**Major Projects
Council Submission
Project Mars Data Centre (SSD-82052708) (Lane Cove)**

Environmental Impact Statement Response for the Project Mars Data Centre at 12 Mars Road, Lane Cove West.

Figure 33: Vacant roof areas (3,023sqm) which should be occupied by solar panels (Source: Roof plan)

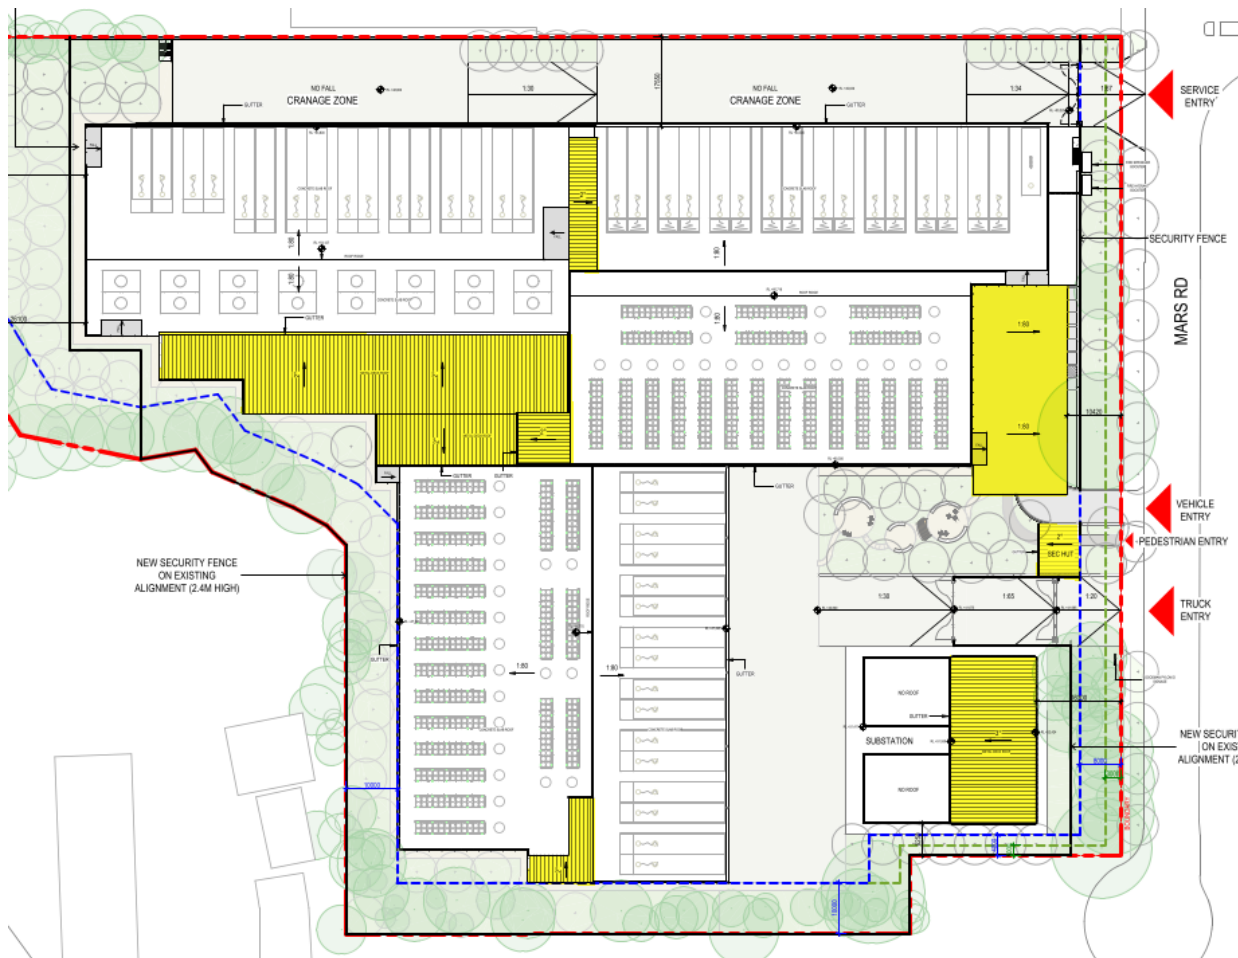
- **2.2 On- site solar** - Data Centres are identified as intensive users of power and the proposed development has not sought to provide any photovoltaic systems. The provision of solar panels is required under Council's DCP and thus Council does not support a design approach where no solar system is proposed. A compliant system should be depicted on the relevant roof plan prior to any determination. The proposed development contains a vacant roof area of 3,023sqm which is a significant opportunity for a solar system which would meaningfully reduce the reliance on electricity used directly from the grid. This area has been depicted in the yellow highlighted sections on **Figure 33** below.
